SUBSURFACE INVESTIGATION REPORT

265 CENTRUM BOULEVARD, OTTAWA, ON, K2S 1V4

Report number: 54-BOI-R2¹
August 29, 2023

This section provides information to amend this report in response to requests made by the City of Ottawa (C of O). The current request in question is: "MEMO / NOTE DE SERVICE; File No. D02-02-23-0021 & D07-12-23-0033" dated June 13, 2023 and it is in the form of the following numbered list:

Figure 2: Test hole Locations Plan

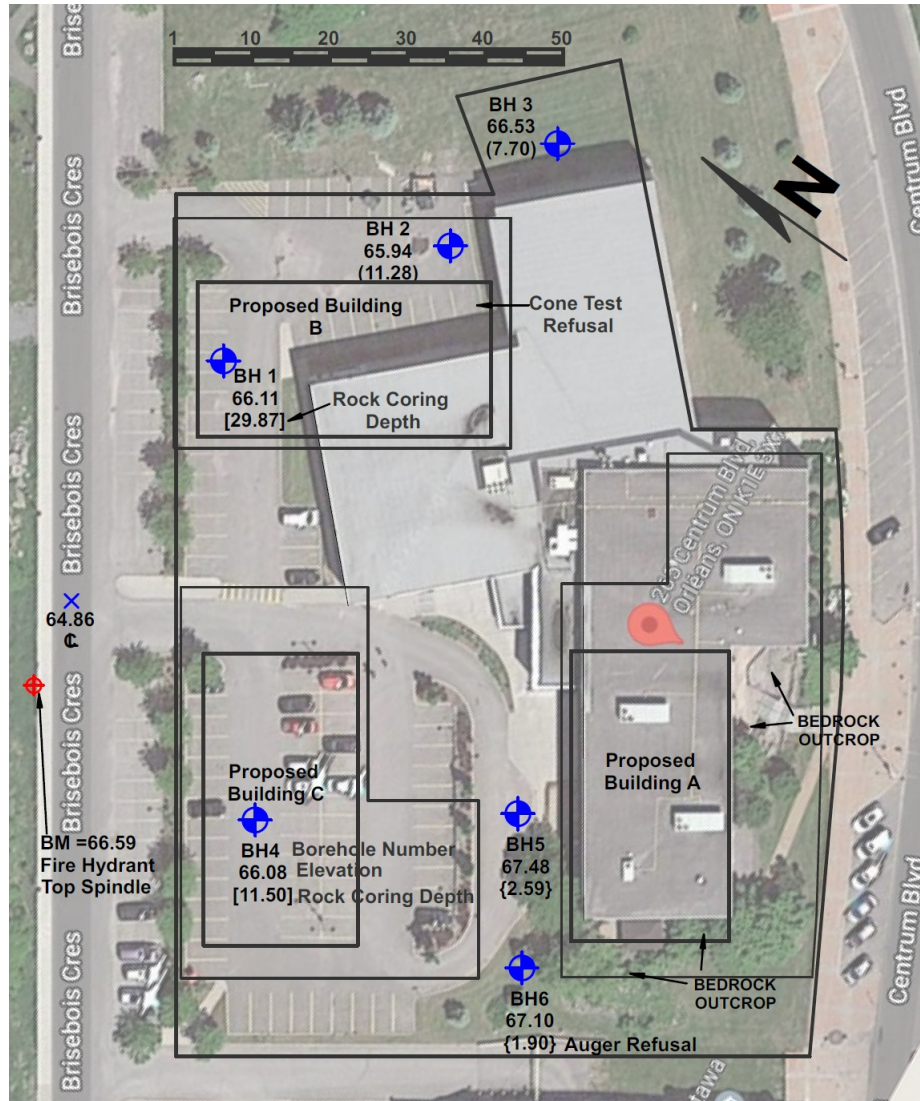
D1. Please clearly specify the spacing between boreholes. Include discussion in the report and refer to Table 1 in the City of Ottawa Geotechnical Guidelines for the maximum allowable spacing between boreholes and test pits. Note that the Geotechnical Guidelines must be upheld and further boreholes would be required should required spacing not be met.

D2. Please include discussion on the choice of location of boreholes, including discussion and justification on the boreholes to which were halted prior to reaching the target depth of 10-15 meters for high-rise developments as per Table 2 of the Geotechnical Guidelines.

Figure 2 in page 23 reproduces fig. 1 in page 9 with an added scale bar. It can be seen that the spacing meets the guideline of up to 50 m spacing between holes.

There are numerous considerations in the decisions leading to a final hole placement in the field. Proposed building footprint, goal for a particular hole or in general, sought information, type of proposed structure and actual space available in the field, buried utilities, proposed investigation budget, etc.

In general, probing bedrock and depth is an important goal at this site. Bedrock probing is generally accepted as a core run that is 1.5 m in length. When probing bedrock, holes are generally halted when the core run length is completed. It is unreasonable to continue coring to 15 m to meet an arbitrary guideline.

In general field programs need to be flexible as it is never known what will be found during drilling. The example at this site, 30 m of drilling when 10 m was expected. 30 m of drilling may well take an entire day of drilling.
